**Southern
Water**

Your ref
Y/63/19/RES

Our ref
PLAN-029278

Proposal: Approval of reserved matters following the grant of Y/1/17/OUT for 56 No. dwellings with associated open space & creation of new access. This application affects the character & appearance of the Yapton (Main Road) Conservation Area & affects the setting of listed buildings.
Site: Y/63/19/RES: - Bonhams, Field Main Road, Yapton BN18 0DX.

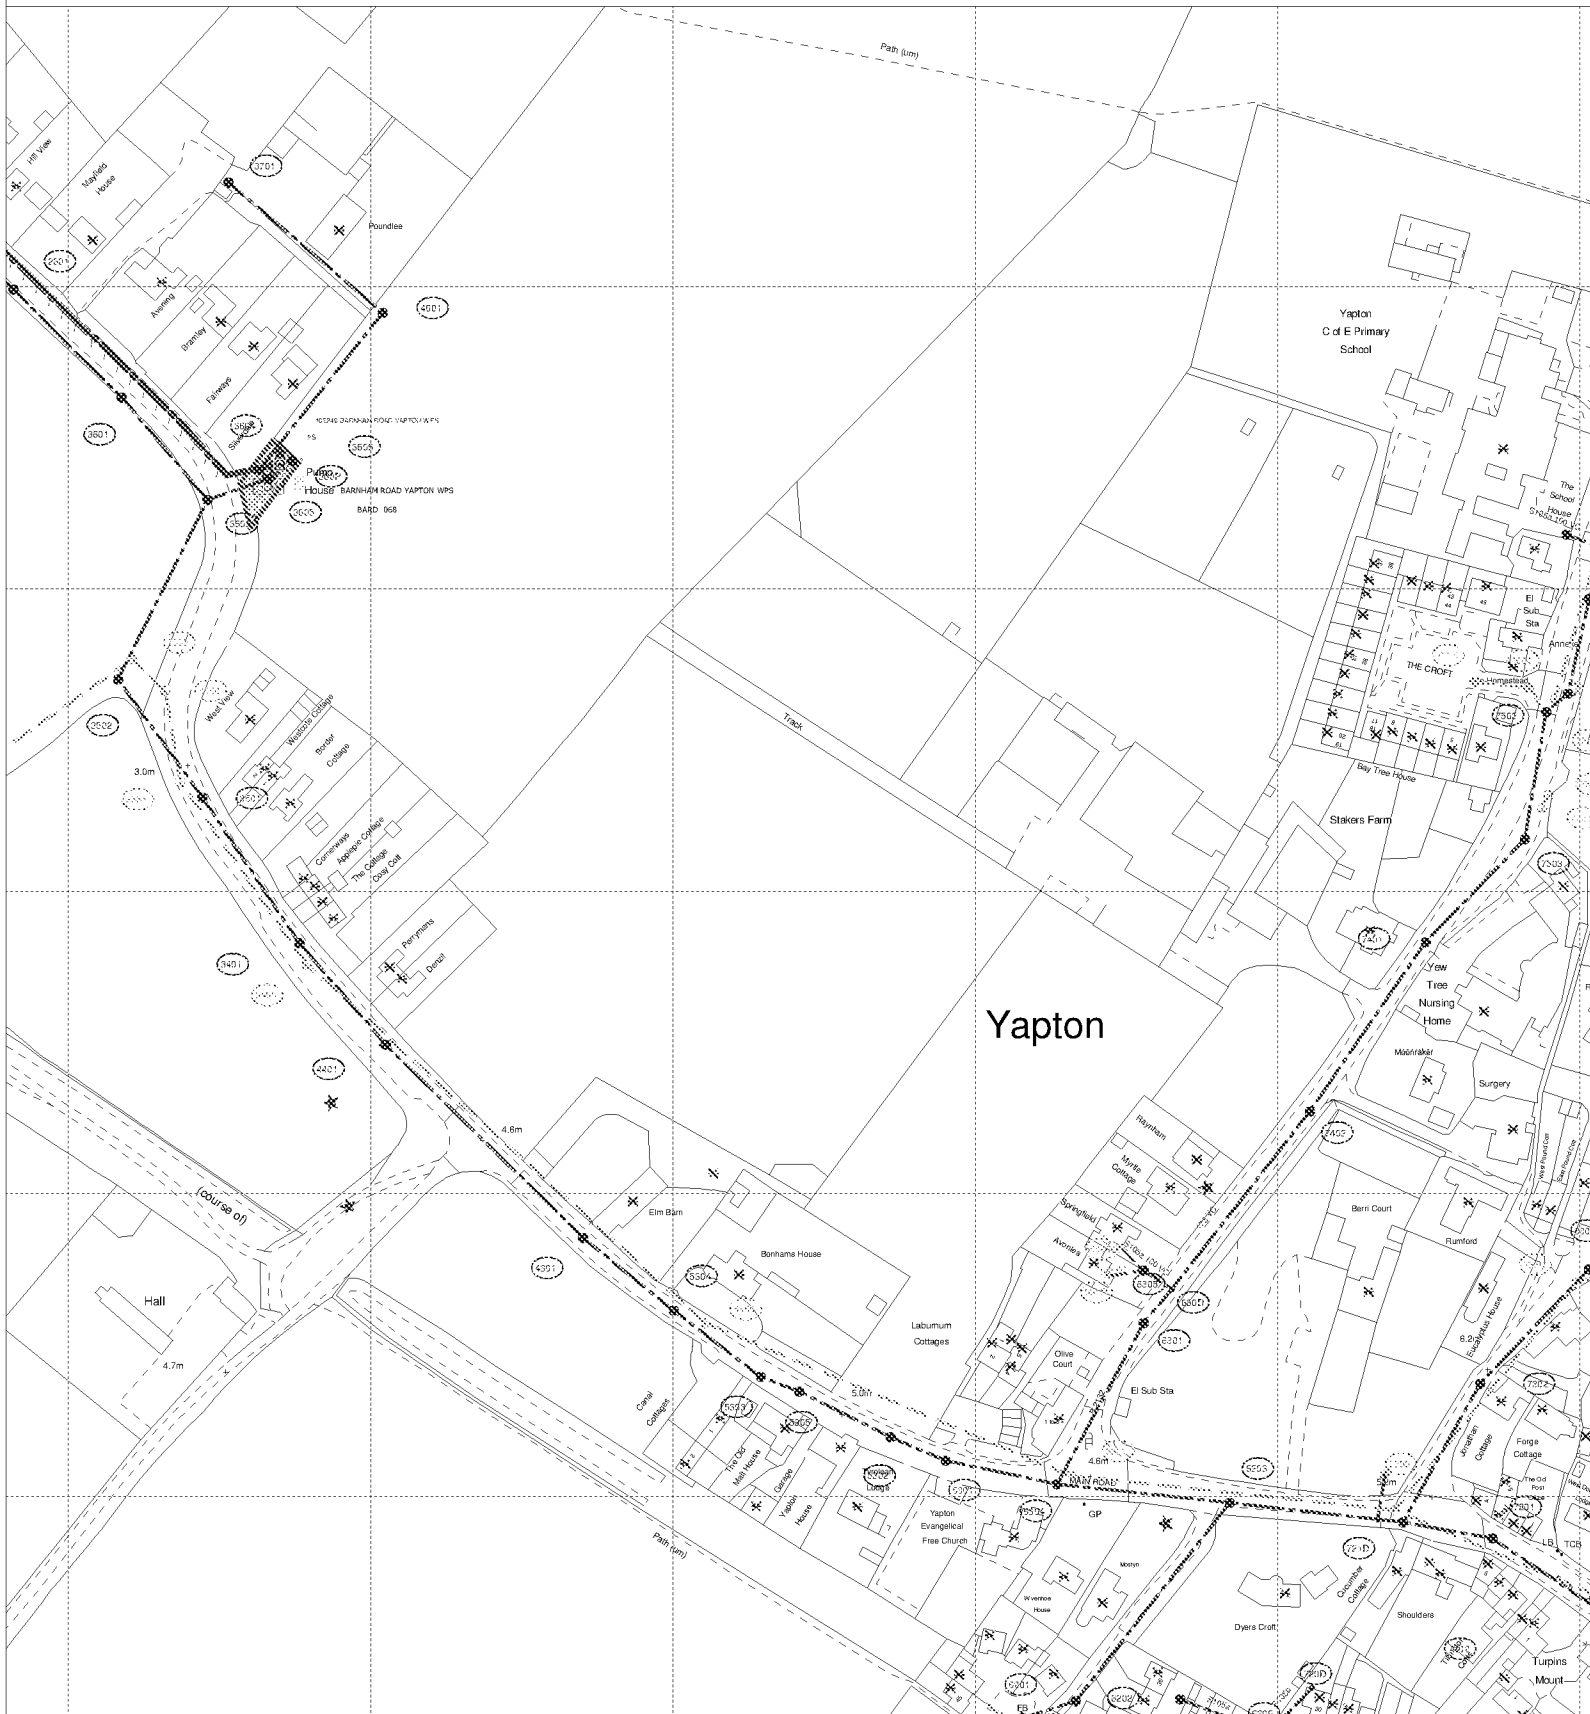
Due to surface water inundation issues in the Lidsey Catchment the applicant is advised to adopt, where appropriate, the measures in the table "Practical measures to reduce the potential impacts of development". Developer should look to protect the public sewerage system from inundation and infiltration, which contribute to flooding in unfavorable conditions.
